Office Action Summary

10/008,386

FURYK ET AL.

DETAILED ACTION

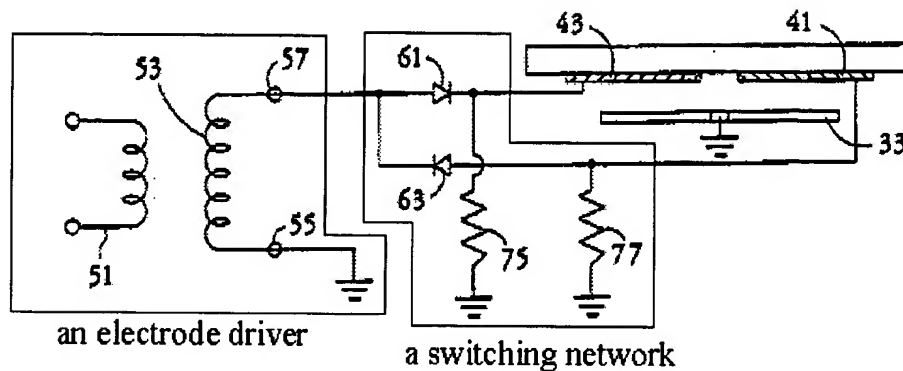
With respect to claim 1, Neukermans et al. discloses micromachined torsion scanner and method thereof in Figure 4 comprising of an electrode driver; and a switching network, coupled to an output of the electrode driver that: in a first configuration, couples the output to a first electrode (43) of an axis of the MEMS device and grounds an opposing second electrode of the axis of the MEMS device, and in a second configuration, couples the output to the second electrode (41) and grounds the first electrode (see Figure 4 below).
